Access Compliance Report

Public Rights-of-Way

(Curb Ramps)

Intersection ID: 9694	Main Street: PEACEFUL_WAY_DR	Cross Street: RISING_OAK_DR	Location: SW
ADA ID: F2A11B8806D5	Ramp Type: Perp	Initial Pass/Fail: Fail	Overall Compliance: No
Severity Score: 12.5			
Codes/Mitigation Info/Possible Solution		Field Measurements/Component Compliance

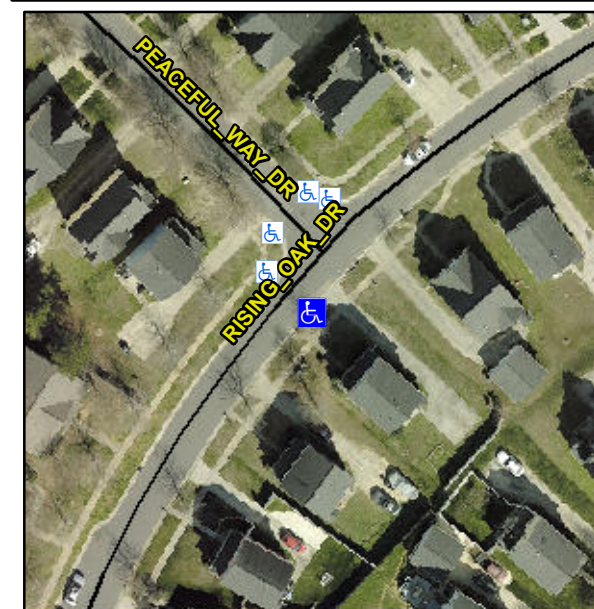
Not Found, R304.2.2

Compliance	Description	Data	Compliance	Description	Data
N/A	Ramp Length (in)	95.0	No	Ramp Slope (%)	8.8
Yes	Ramp Width (in)	48.0	Yes	Ramp XSlope (%)	0.3
N/A	Flare Type LT	N/A	N/A	Flare Type RT	N/A
N/A	Flare Slope LT (%)	N/A	N/A	Flare Slope RT (%)	N/A
N/A	Flare Traversable LT?	N/A	N/A	Flare Traversable RT?	N/A
N/A	Landing Length (in)	N/A	N/A	DWS Provided?	N/A
N/A	Landing Width (in)	N/A	N/A	DWS Contrast?	N/A
N/A	Landing Slope (%)	N/A	N/A	DWS Length (in)	N/A
N/A	Landing X Slope (%)	N/A	N/A	DWS Full Width?	N/A
N/A	Landing Curb? (Y/N)	N/A	N/A	DWS Offset (in)	N/A
N/A	Shared Landing?	N/A			
N/A	Gutter Ponding?	N/A	N/A	Gutter Slope (%)	N/A
N/A	Gutter Lip Ht (in)	0.75	N/A	Gutter X Slope (%)	N/A
N/A	Painted X Walk1?	No	N/A	Painted X Walk2?	N/A
	X Walk 1 Direction	To NW		X Walk 2 Direction	N/A
N/A	X Walk 1 Width (in)	N/A	N/A	X Walk 2 Width (in)	N/A
	X Walk 1 Slope (%)	4.2		X Walk 2 Slope (%)	N/A
	X Walk 1 X Slope (%)	1.8		X Walk 2 X Slope (%)	N/A

Remove & Replace Entire Ramp.
